GREAT WESTERN RAILWAY.

INTRODUCTION OF UP HUMP YARD AT SEVERN TUNNEL JUNCTION.

On **SUNDAY, NOVEMBER 5th, 1939**, between the hours of 9.0 a.m. and 5.30 p.m., or until the work is completed, **THE SIGNAL DEPARTMENT WILL BE ENGAGED BRINGING INTO USE SEVERN TUNNEL JUNCTION UP HUMP YARD CONTROL BOX**, situated on the Up side of the Hump Line, near the 149 $\frac{3}{4}$ mile post, working the signal leading over the Hump Line and the connections leading into the new Hump Yard.

SEVERN TUNNEL JUNCTION UP HUMP YARD CONTROL BOX.

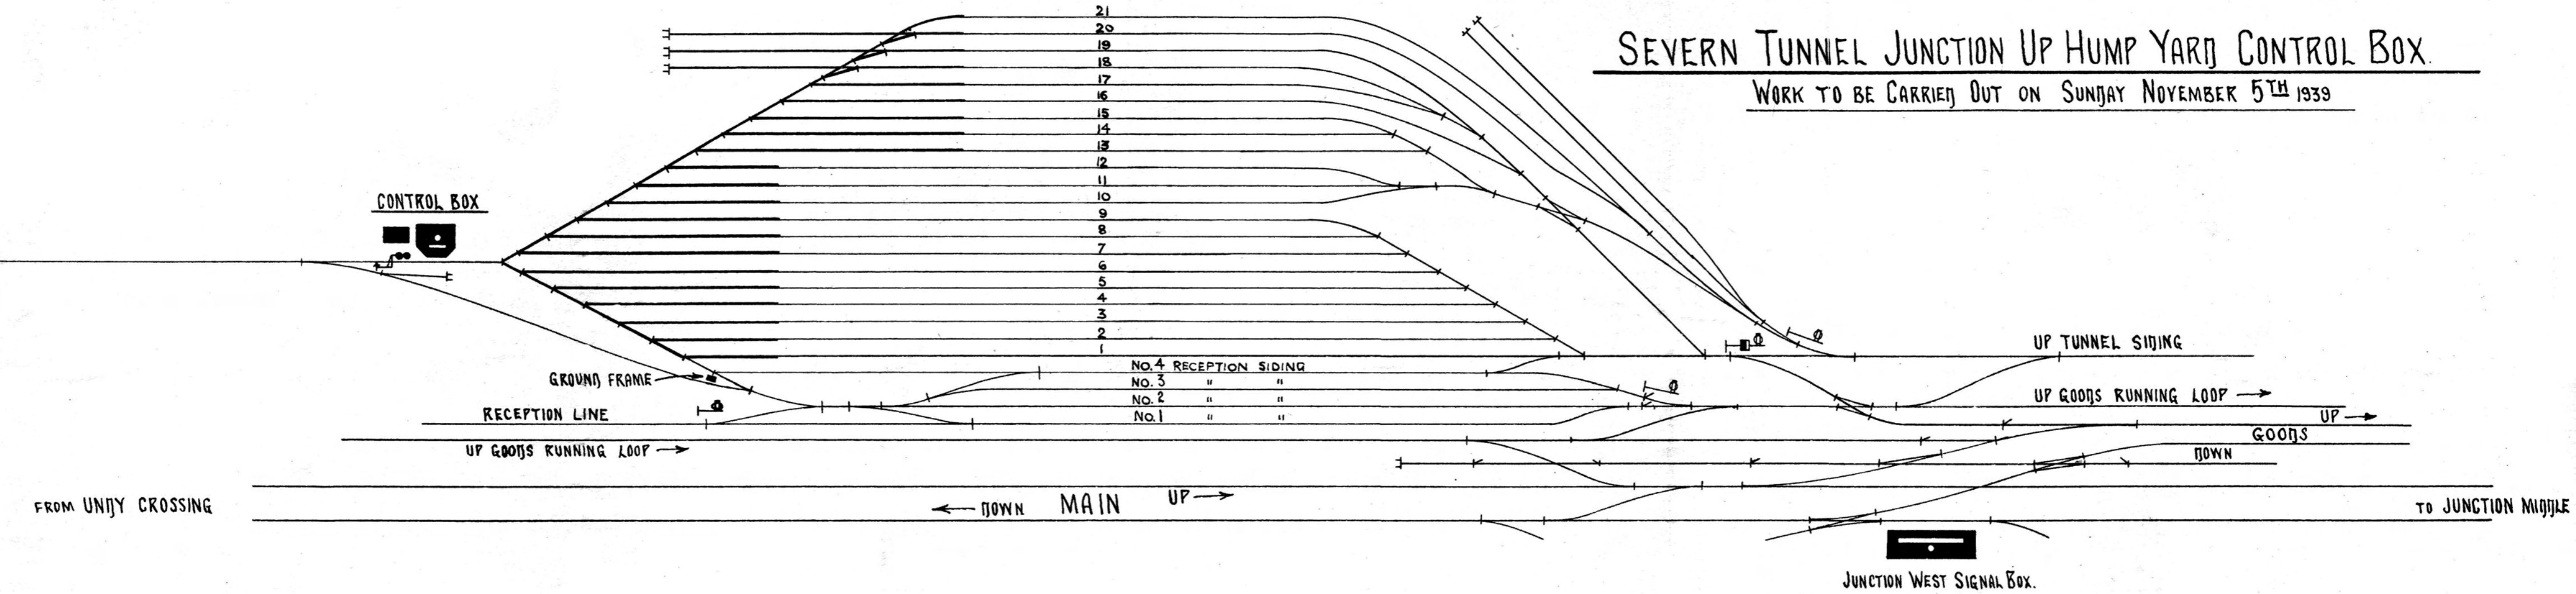
The following new signal will be brought into use :—
TWO-ASPECT COLOUR LIGHT SIGNAL.

New connections will be brought into use as shewn on the attached sketch.

A new two-lever Ground Frame will be brought into use, fixed between Hump Sidings and line leading to Hump Spur, controlling thumb switch in Hump Yard Control Box for movements beyond No. 1 Hump Siding and working existing signal leading from Reception Line to Nos. 1, 2, 3, and 4 Reception Sidings.
